Amendments to the Drawings:

REMARKS**I. Status Of The Claims**

Fig. 1

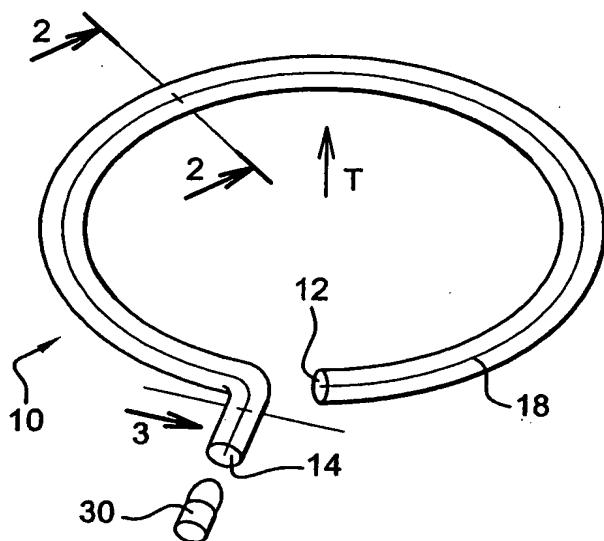
In the October 18, 2005 Office Action, the Examiner noted that Figures 1-3 of the present application are labeled “art antérieur” instead of “Prior Art.” The Examiner objected to the Figures because each of the reference numerals “26” and “34” are recited in the specification with regard to two different features of the present invention. The Examiner also objected to Figures 8 and 9 because they do not include reference numeral “24” as described on pages 14 and 15 of the specification.

In response to the Examiner’s comments and objections, Applicants submit herewith a set of corrected drawing sheets. Figures 1-3 have been amended to substitute the label “Prior Art” for the original label “art antérieur.” In addition, Figures 8 and 9 have been amended to include reference numeral 24 to identify the “rear peripheral portion 24” as described in the specification at pages 14 and 15.

"Prior Art" substituted
for "art antérieur"
